From: Anna Tidey
Sent: 21 July 2025 12:00:13 UTC+01:00
To: "Simon Bareham" <simon.bareham@lewisplanning.co.uk>
Subject: RE: Barn 2 - Amended Plans for Application DM/25/1025 - Providence Farm, Colwood Lane, Warninglid

From: Simon Bareham <simon.bareham@lewisplanning.co.uk>
Sent: 21 July 2025 09:03
To: Anna Tidey <anna.tidey@midsussex.gov.uk>
Subject: RE: Request for Amended Plans/Follow up to site visit for Applications DM/25/1024 and DM/25/1025 - Providence Farm, Colwood Lane, Warninglid

As submitted for DM/25/1025 – for Barn 2 - Existing/as built elevations, Sections and Plan – Drawing ref FRFC_Wrngld_04_BR_EX_02:

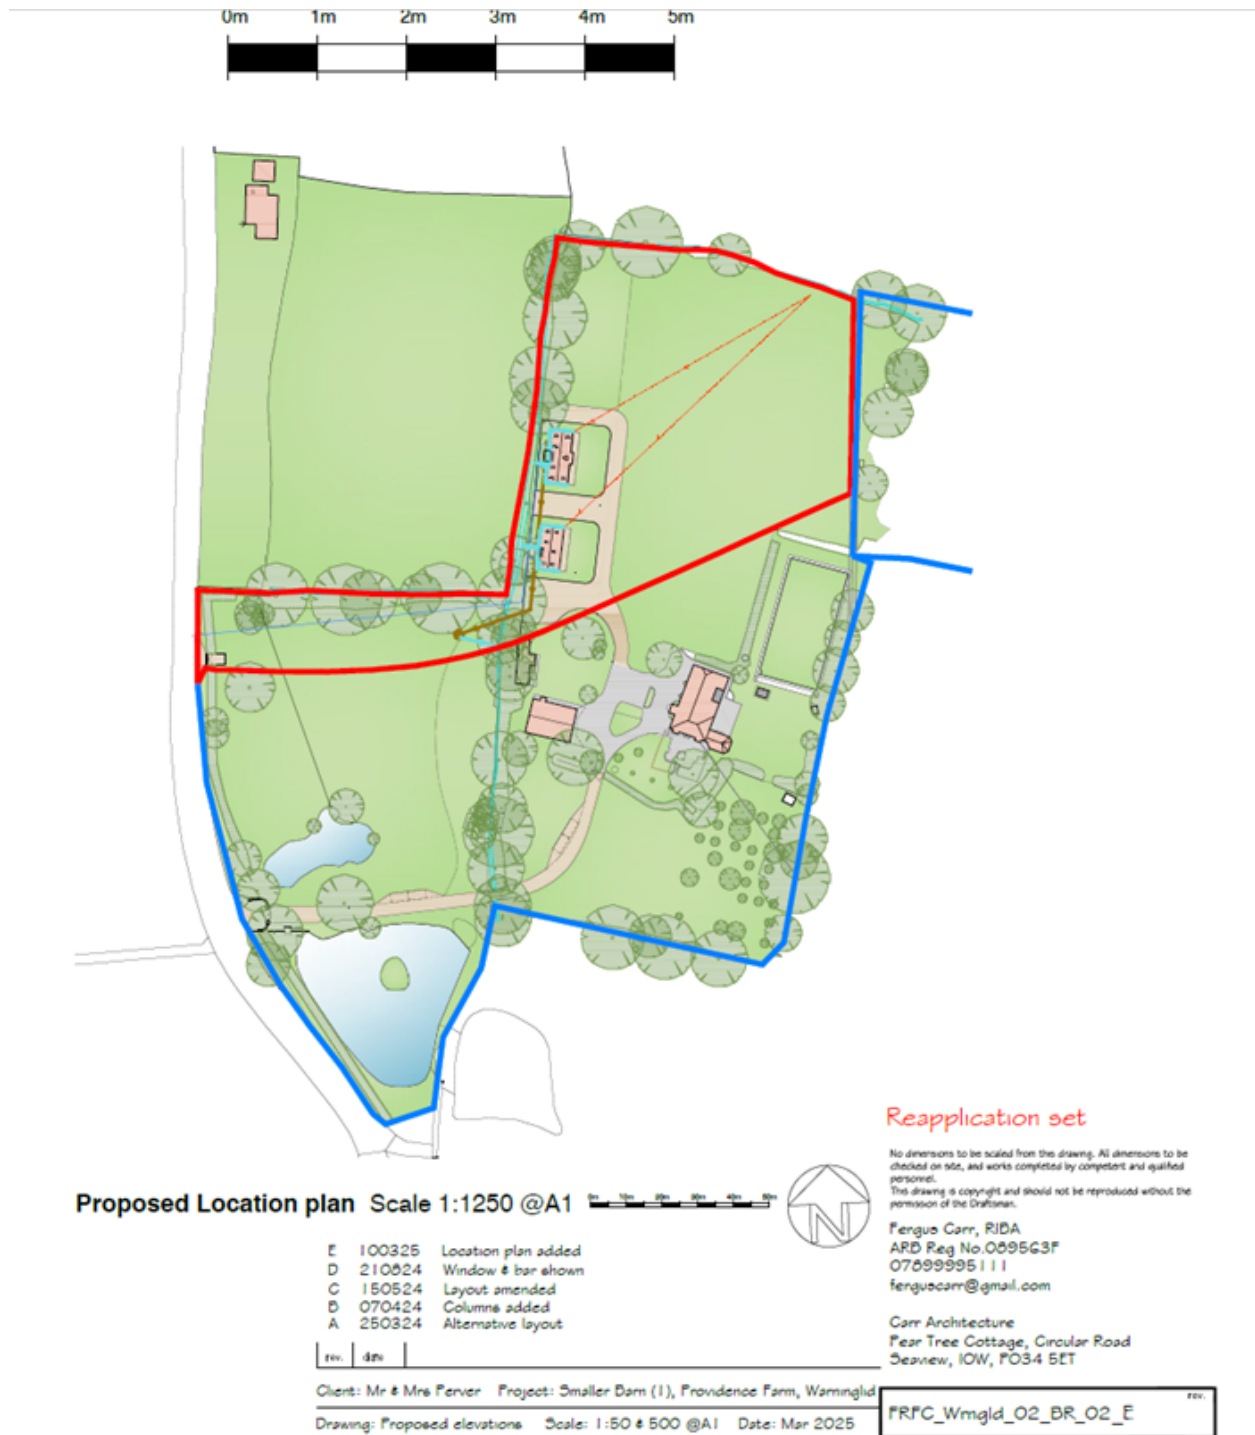
I am working on my reports for DM/25/1024 and DM/25/1025 this afternoon. Unfortunately I shall be unable to recommend the applications are approved as they both include Location Plans that show a red line extended around a second separate vehicular access point to serve the barns, which has not been approved. For your information please see the access plans below.

In order to take the applications forward to a positive recommendation I shall be grateful if you can please provide a revised Proposed Elevations and Location Plan with the red line to accord with the approved plan.

A change to the front door at Barn 2 has also taken place, with a glazed door in place of an approved solid central door in the eastern facing elevation. **May I suggest that the Proposed Plans for DM/25/1024 (Drawing ref FRFC_Wrngld_04_BR_EX_02) is also amended to correctly reflect the works that have been carried out on site.**
